**Subject: Response to Comments  
Pre-Final Remedial Design Report, Drawings and Specifications  
MIG/DeWane Landfill Superfund Site (Site)  
Belvidere-Boone County, Illinois**

### **Responses to IEPA Comments**

FIGURE 1 - TOP DECK GRADING ANALYSIS

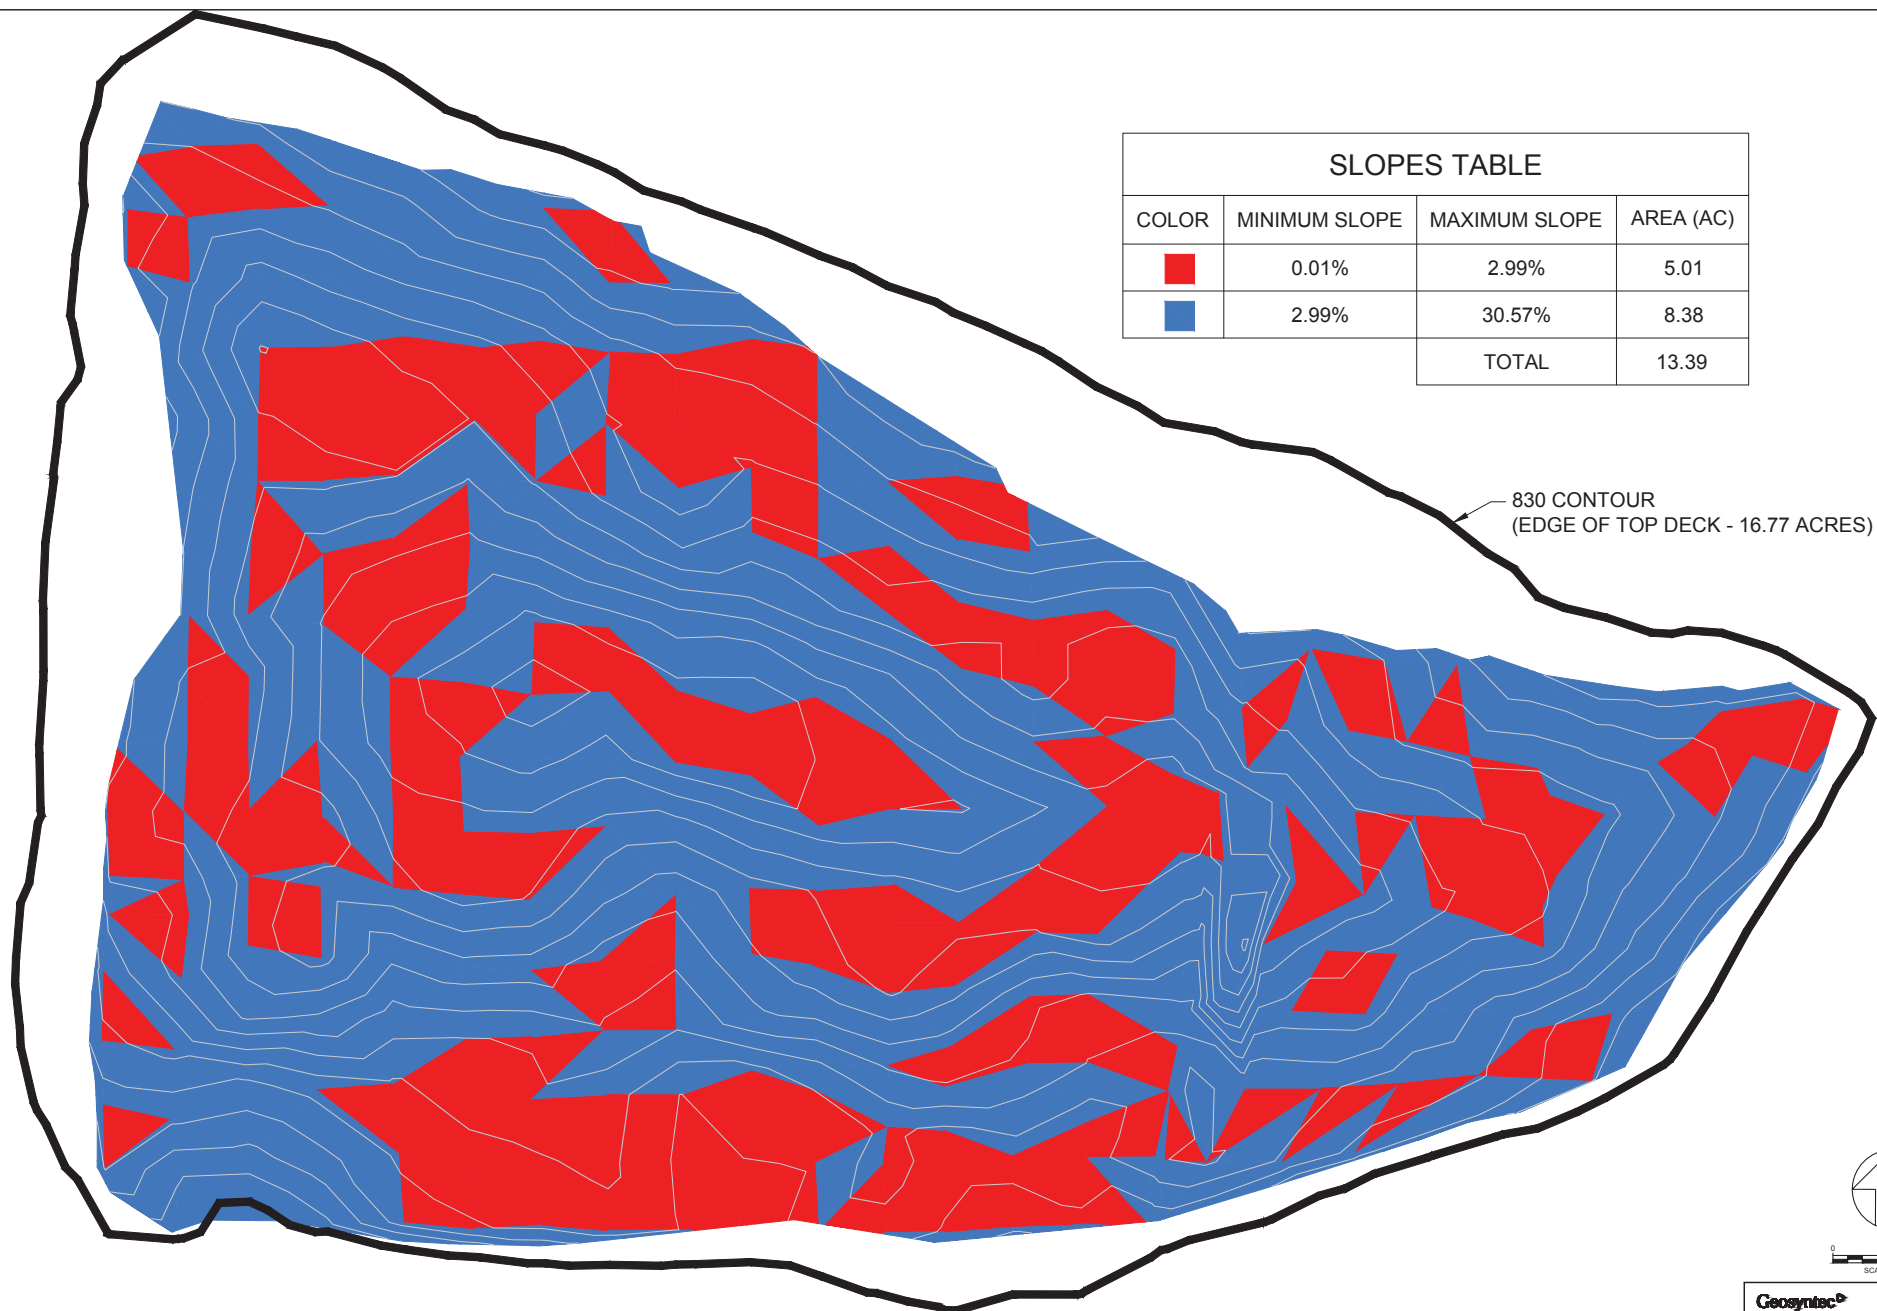
1. The estimate of the area of the top deck of the landfill in the Modified Remedy Technical Memorandum (Tech Memo) was based on a survey completed in 2006 (2.5-3.4 acres, 15-20% of the top deck). Prior to the start of the Pre-Final Remedial Design (RD), a new survey of the landfill was completed and found that approximately 5.0 acres (approximately 30%) of the top deck of the landfill was below the required 3.0% grade due to additional differential settlement of the landfill since 2006 (see attached **Figure 1**). Unfortunately, the areas with grades less than 3.0% are not adjacent and are spread out across the top deck of the landfill (see **Figure 1**). The spacing of the areas with grades less than 3.0% and the associated fill required to bring the grades up to

3.0% also require grading of adjacent areas to blend in the filled areas to have a consistent 3.0% grade throughout the top deck of the landfill. Of the approximate 16.8 acre top deck, approximately 13.4 acres (80%) requires earthwork to meet the minimum 3.0% grade.
